**Re: Simon Kenton Council - BSA - Camp Lazarus  
NPDES Permit 4PX00055/ OH0142409  
Reconnaissance Inspection  
Delaware County**

NPDES Compliance Inspection Report

#### 8.51 Filter Sand Specifications

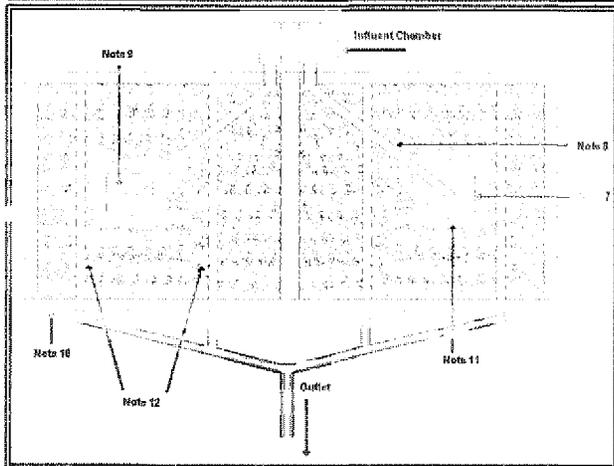
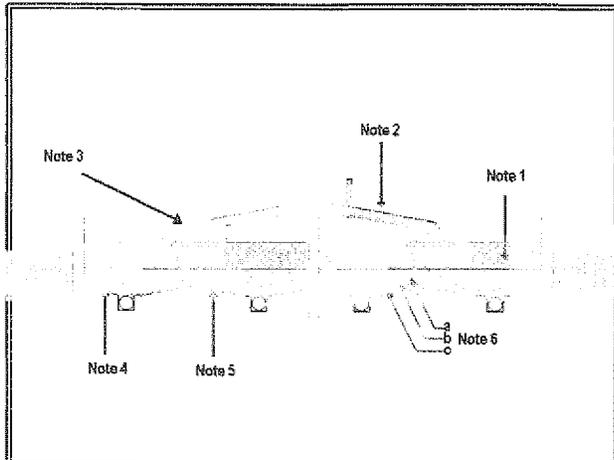
2. The tertiary sand filters were ponded and appeared to be clogged with leaves. The operator indicated that maintaining the filters in working order is a time consuming task given that the plant is surrounded by large trees. The operator has plans to replace the sand media this summer to improve flow through the filters. We also discussed the installation of filter fabric over the sand to facilitate cleaning and to reduce the solids loading on the filters. The facility reported a

suspended solids concentration of 119 mg/L in August 2012. I've included information on the required sand depth and specifications as well as the name and number of two suppliers that I'm aware of in our district. The operator also indicated that he intends to excavate a trench around the perimeter of the filters to preclude surface drainage from entering the filters.

- A) Filter sand shall be clean and washed. The sand should have an effective size between 0.4 and 1.0 mm and a uniformity coefficient not greater than 4.0. In addition, less than 4% should pass a #100 sieve.<sup>22</sup>

**Recommended Filter Sand**  
This sand specification is recommended for sand filters. However it may not be readily available in the State of Ohio. The selected sand should be as close to the recommended specification as feasibly possible. When selecting sand for sand filters, sand that is too coarse does not provide adequate filtration. Sand that is too fine washes away. Sand with excessive fines can pass through into the underdrains and diminish capacity. Unwashed sand can have particulates pass through into the effluent and show up as a total suspended solids violation.
